**CHARLOTTE - MECKLENBURG  
PLANNING COMMISSION**

**SUBJECT:** administrative approval for petition NO. 98-04(C) by Centex Homes Tax parcels  
229-012-77,79 and 229-021-04 and 12.

**MARVIN ROAD SITE  
 REZONING**  
 FOR CENTEX HOMES  
 MECKLENBURG COUNTY, NORTH CAROLINA

**TECHNICAL DATA SHEET**  
 PETITION NO. #98-04(c)  
 FOR PUBLIC HEARING

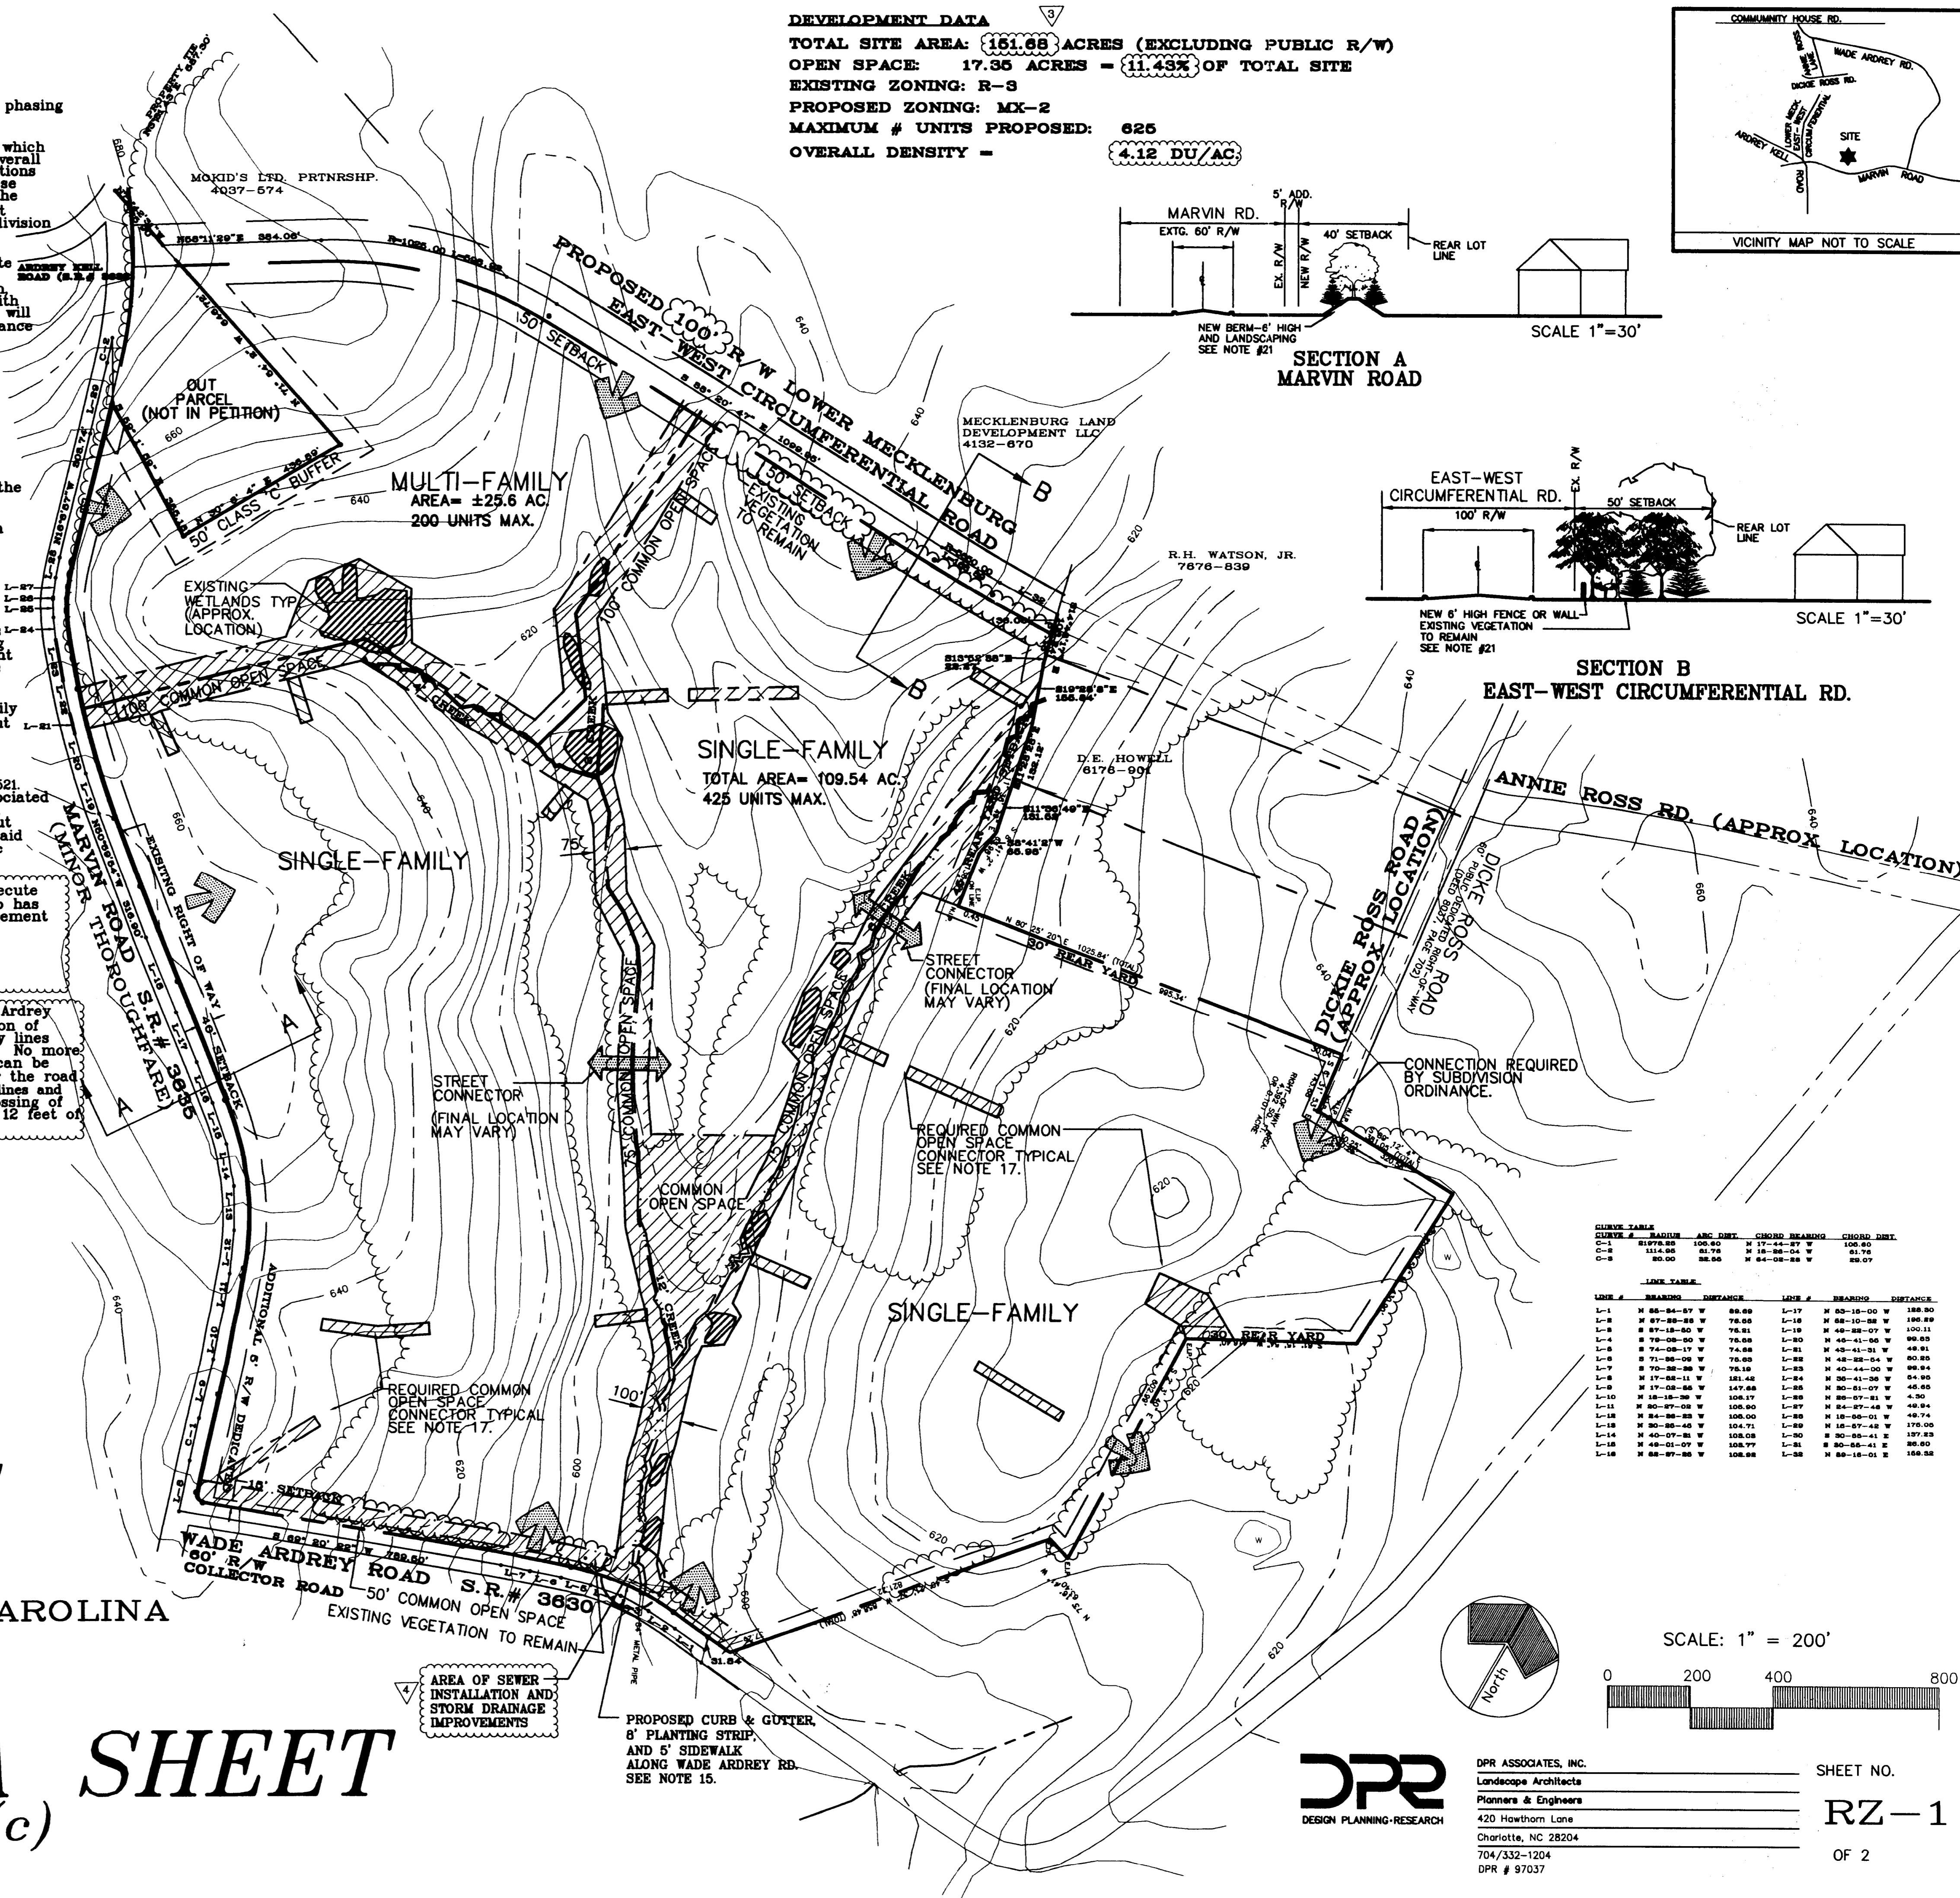
attached is a revised plan for the above rezoning petition. The plan indicates a 12 foot area to be disturbed within the common area along Wade Ardrey Road for roadway improvements and an area to be disturbed for sewer and drainage improvements. Since this change is minor, I am administratively approving this revised plan. Please use this revised plan when evaluating requests for building permits and certificates of occupancy.

attached is a revised plan for the above rezoning petition. The plan reflects revised notes that all single family yard and buffer dimensions shall be measured from the common open space boundaries (this is a clarification); grading will be allowed in the buffer necessary to prepare the multi family area; multi family building height and number of stories are to be measured from front of buildings and basements are permitted. Since these changes are minor, I am administratively approving this revised plan. Please use this revised plan when evaluating requests for building permits and certificates of occupancy.

- All yard and buffer dimensions shall be measured from the common open space boundaries.
- Petitioner/developer shall provide left turn lanes at the two proposed access points along Marvin Road. The turn lane shall be constructed at the time each driveway is constructed. Also, the petitioner/developer shall widen Marvin Road to a minimum of 12 feet of pavement from the centerline along the site's frontage if the existing total width of the road is less than 22 feet.

- The petitioner shall provide sidewalks as shown on the Schematic Site Plan.
- Existing vegetation to remain along Wade Ardrey Road except as required for the installation of improvements, storm drainage, utility lines, sight triangles, and entrance monuments. No more than 12 feet of the common open space can be graded from the right of way to allow for the road improvements. The installation of the sewer lines and upgrading of the culvert at the creek crossing of Wade Ardrey Road will disturb more than 12 feet of existing vegetation.
